## PLANNING AND ZONING COMMISSION MEMORANDUM

**SUBJECT:** SDP 2016-05 Public Hearing and consideration of a request from Skeeter & Bucky, LP, for a Special Development Plan for Iron Horse Village on 9.17 acres located in the 6300-6400 blocks of Iron Horse Boulevard.

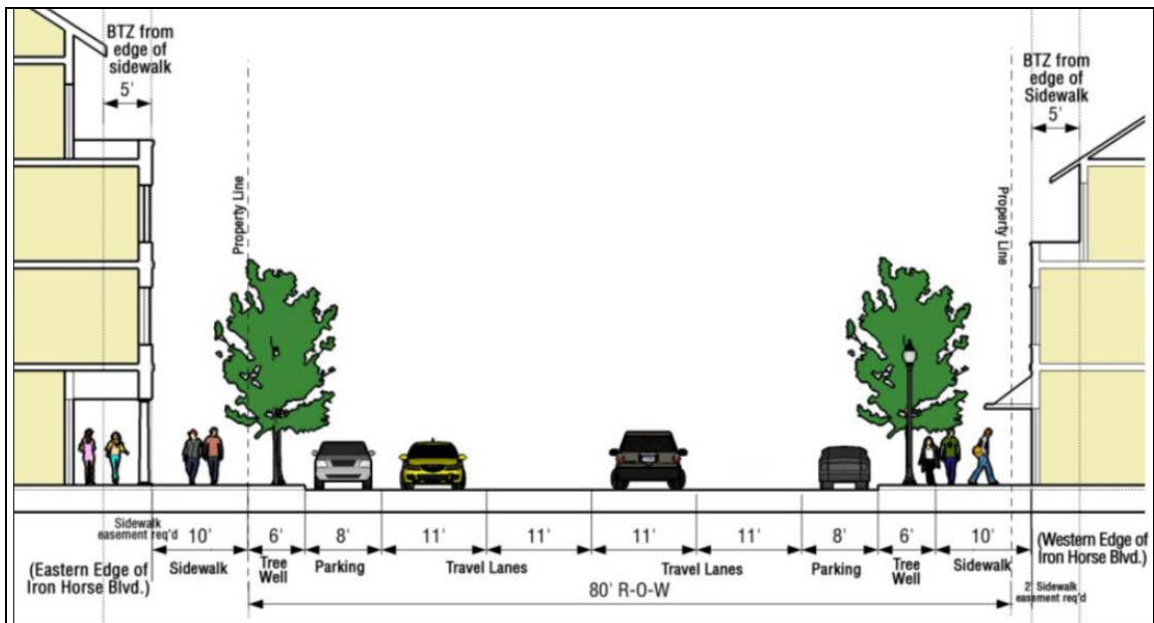
The applicant is proposing 1.42 spaces per multifamily unit in Phase 1 and is proposing to apply this reduced residential parking ratio to the 28,000 square feet of Flex Commercial space. As shown, their Phase 1 plan is deficient by 69 parking spaces if commercial parking ratios were to be correctly applied to the 28,000 square feet of Flex Commercial area. The total Buildout plan is also deficient by 42 spaces.

This does not account for the leasing and amenity center use. Below is a breakdown of the parking proposed by this development.

Because the intent of Transit Oriented Development is to create a walkable mixed-use urban environment, the baseline parking requirements are already established at lower levels than conventional suburban standards. In other words, there are already fewer parking spaces provided in TOD than in a suburban shopping center or apartment complex. Waivers to the TOD's minimum parking standards may cause issues with parking availability as well as the ability to lease commercial space.

**Figure 3: Requested TOD Code Waivers / Variances**

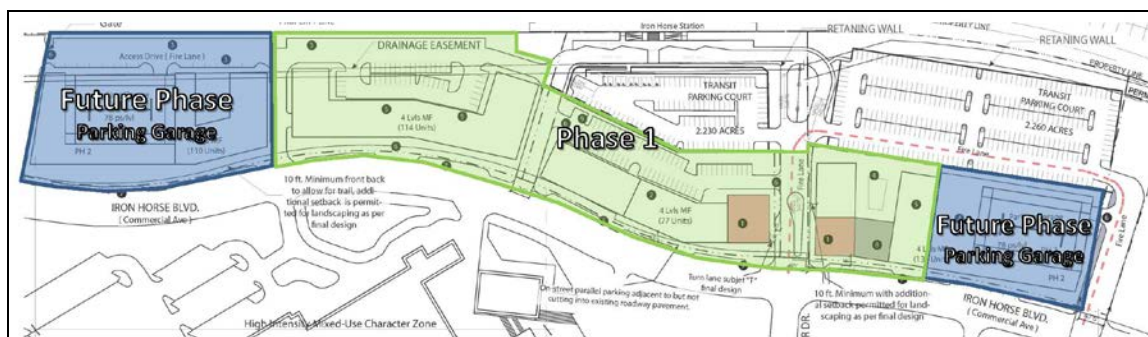
2. <i>Sec. 118-566(b) &amp; (c)</i> First Floor Height	Min. 15-foot floor-to-floor ceiling height	No waiver sought	Residential first floor standards on Buildings C, D and portion of A

3. <i>Sec. 118-566(b) &amp; (c)</i> Parking Ratios	1.5 spaces per multi- family residential unit	Phase 1: 1.38 spaces per residential unit	Phase 1: 1.62 spaces per residential unit
	1 space per 250 square feet of non-residential	Build-Out: 1.37 spaces per residential unit  Did not account for commercial parking  Flex unit areas counted at residential parking ratios	Build-Out: 1.65 spaces per residential unit  <i>Above ratio does not account for commercial parking</i>  Flex unit areas counted at residential parking ratios
<i>See additional breakdown/details in Figure 2</i>

4. <i>Sec. 118-565(d)</i> Structured Parking	80% of required parking maintained as onsite structured parking	Phase 1: 5.6% of parking provided as tuck-under garages  Build-Out: 79% of parking provided as structured and tuck-under garages	Phase 1: 4.7% of parking provided as tuck-under garages  Build-Out: 57% of parking provided as structured and tuck-under garages
